## Response to the Reviewers' Comments

The authors would like to thank the reviewers for the precious comments and suggestions on the technical contents and presentation of our manuscript "Runtime Power Management of Battery Electric Vehicles for Extended Range with Consideration of Driving Time," submitted to IEEE Transactions on Very Large Scale Integration (TVLSI.) This revised manuscript has been greatly improved thanks to the reviewers' invaluable advices. We have revised the manuscript faithfully following the reviewers's comments. We include the newly added or significantly modified parts in the revised version of the paper also in Response to Reviewers. We highlight the important technical content changes and set those parts in a red color in the revised paper.

Fig. 2: (a) Range-speed experimental data for Chevrolet Bolt [36] and (b) comparison with simulation results of the proposed EV power model.

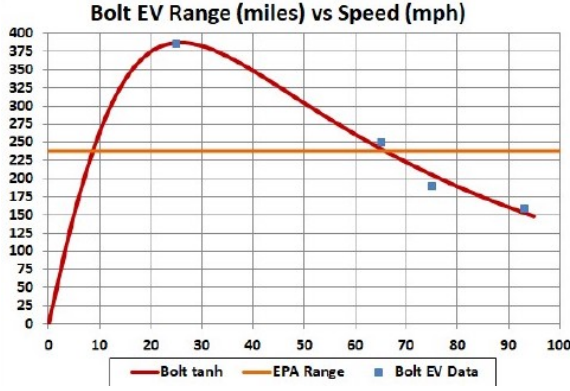
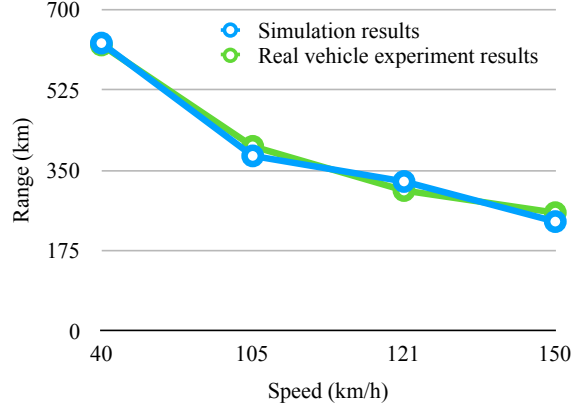
**R1-C2** It is not clear how to validate the power model of EV. As the author mentions that accuracy of power model is quite important, it is good to see the power model in this paper can be validated by some real measurement results.

Here goes how we extracted correct coefficients of the EV power equation. We use a vehicle simulator that supports EV as well, ADVISOR, to extract the coefficients of new vehicles starting from known vehicle specifications such as the aerodynamic resistance, rolling resistance, curb weight, and so on. Such data is often published in the users' manual, website and so forth. We further use the vehicle performance data such as the top speed, maximum acceleration, and so on, which are also available on the manuals and website. We iteratively run ADVISOR and derive the model coefficients so that all the known values match among each other. We evaluate the model accuracy with the range-speed real vehicle experiments as shown in Fig. 1(a), which has been published by [32], [33], [34], [35], [36]. We further refine the coefficients until all the available data values match well. Finally, the derived EV power model well matches with the range-speed experimental data as shown in Fig. 1(b) as well as the top speed and maximum acceleration, setting the aerodynamic resistance, rolling resistance, curb weight, etc. with the known (fact) values. The errors of the range-speed simulation is merely 1.4%, the time to approach 60 mph at departure is 7.8%, and the top speed is 3.0%, respectively. We revised the manuscript adding the following paragraph with a new figure in Section III-A on page 3 and 4.

We further evaluate the model accuracy with the range-speed real vehicle experiments as shown in Fig. 2(a) to confirm the derived power models are close enough to the real vehicle measurement data [32], [33], [34], [35], [36]. We refine the coefficients until all the available data values match well.

As a result, the derived EV power model well matches with the range-speed experimental data as shown in Fig. 2(b) as well as the top speed and maximum acceleration setting the aerodynamic resistance, rolling resistance, curb weight, etc. with the known values. The errors in the range-speed simulation is merely 1.4%, the time for 0-to-100 km/h error is 7.8%, and the top speed error is 3.0%, respectively.

Fig. 12: Velocity profile comparison with  $EDP$ ,  $E^2DP$  and  $E^3DP$  on Jones Street in San Francisco.

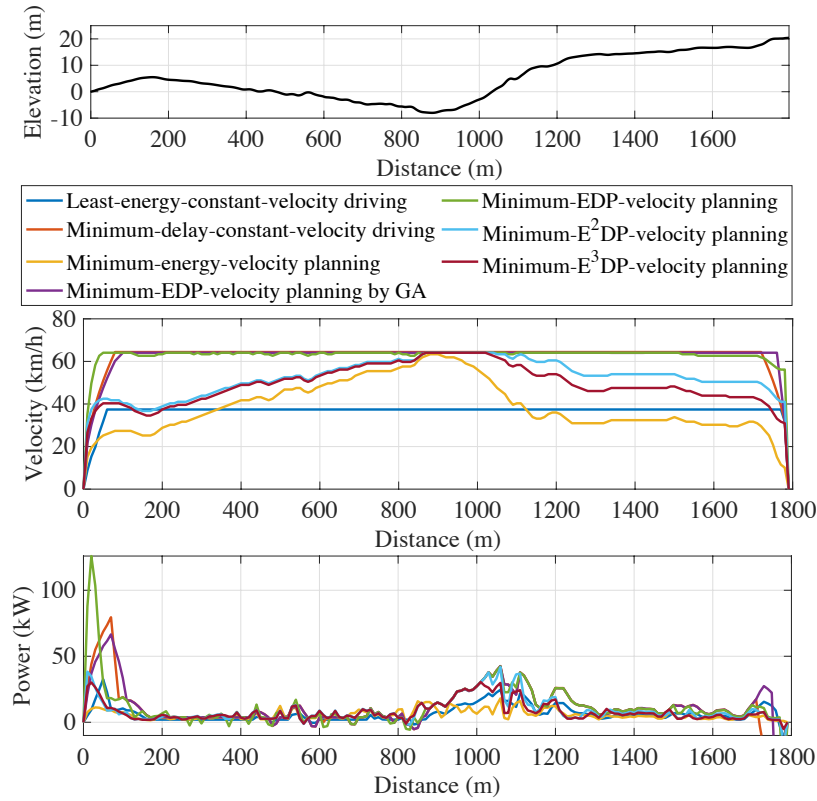
**R1-C3** The optimality of the proposed scheduling algorithm is unclear. The author should add several paragraphs to discuss this topic. It is also to see the comparison baseline is well accepted to show the advantage of the proposed algorithm.

Fig. 12 summarizes  $EDP$  of the least-energy-constant-velocity driving, the minimum-delay-constant-velocity driving, the minimum-energy-velocity planning, the velocity planning with  $EDP$ ,  $E^2DP$  and  $E^3DP$  as a metric on the road benchmarks and the minimum- $EDP$ -velocity planning with GA. The proposed velocity planning results in up to 46.2% improvements of  $EDP$  compared with the least-energy-constant-velocity driving. The driving velocity on a flat road is faster than that of the least-energy-constant-velocity driving at the expense of relatively little energy to save driving time. Then, the velocity decreases when climbing the following uphill to spend less motor torque, which saves more energy.

In addition,  $EDP$  of the proposed EDP-aware-velocity planning is merely 4.3% higher than that of the true EDP-minimum-velocity planning on average. Through this results, we confirm that the results of the proposed heuristics are close enough to the true optimal solutions.

We also updated Fig. 12 and Fig. 13:

Fig. 11: Histograms of velocity and acceleration for the proposed energy-aware-velocity planning methods without an acceleration constraint (a) and (b) and with an acceleration constraint (c) and (d), respectively.

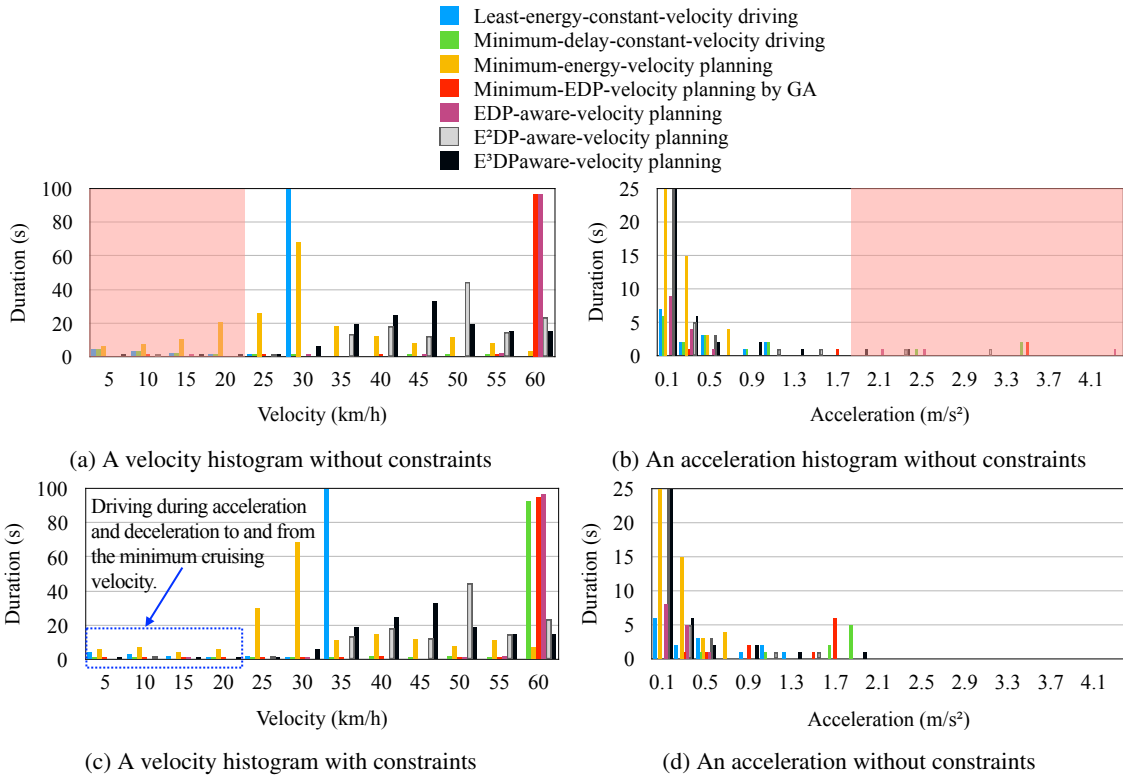
**R2-C2** It would be good to have more discussion on the assumptions of the approach and the experiments, e.g., how much can the velocity be changed in practical scenarios without impeding traffic and causing unsafe situations (also depending on the road conditions and whether it is urban or rural environment I suppose). Currently, there only seems to be one constraint on not slower than 10 km/h.

Fig. 11(a) and (b) show two histograms of the driving schemes in Fig. 12, which do not have velocity and acceleration constraints. We avoid a cruising velocity lower than 25 km/h and an acceleration higher than  $2.0 \text{ m/s}^2$  in this paper without loss of generality. The acceleration of  $2.0 \text{ m/s}^2$  is the same as the maximum acceleration of compact cars designed to be used primarily used in urban areas (13 seconds of 0 to 100 km/h time).

Fig. 11(c) and (d) shows the velocity and acceleration histograms with the constraints. Once we run the DP for the first time without constraints, we analyze the histogram, adaptively determine the minimum cruising velocity and maximum acceleration constraints, and run DP again. We keep the same constraints for online recomputation whenever unexpected interrupts occurs.

We also enforce the minimum acceleration not lower than  $1.0 \text{ m/s}^2$  when the EV starts from a stop sign or a traffic light until the velocity reaches to the minimum cruising velocity not to bother traffic flow. The acceleration of a  $1.0 \text{ m/s}^2$  exhibits 6 second delay to reach 25 km/h. The maximum speed is bounded by the speed limit of each road benchmark.

Fig. 8: Altitude changes in the real road benchmarks.

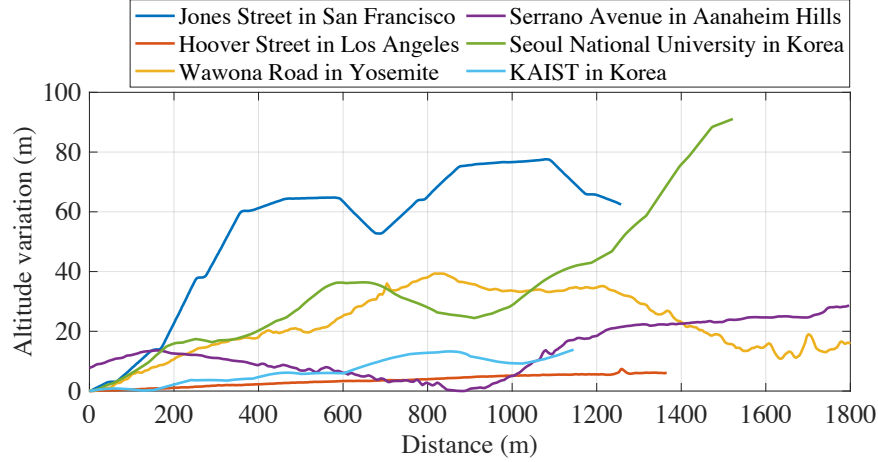
**R2-C3** Related to the last point, it would be good to have more discussion on the road benchmarks, e.g., how they are generated and how representative they are. The optimization results significantly depend on road slope. It would be good to use a variety of real road segments for testing.

**R2-A3** We appreciate the reviewer's comment and added six new real routes from various locations in California. The first three roads are in cities. Jones Street in San Francisco and Hoover Street in Los Angeles are two representative city landscapes such as hills and flat roads, respectively, and Cliff Drive in Santa Barbara is a mixture of those. The second two roads are in mountain areas: Serrano Avenue in Anaheim Hills and Otay Lakes Road in San Ysidro Mountain in California. The last road is Junipero Serra Boulevard connecting San Francisco and San Jose. The details of road data is summarized in Table II, and Fig. 8, which visualize the altitudes of the road benchmarks.
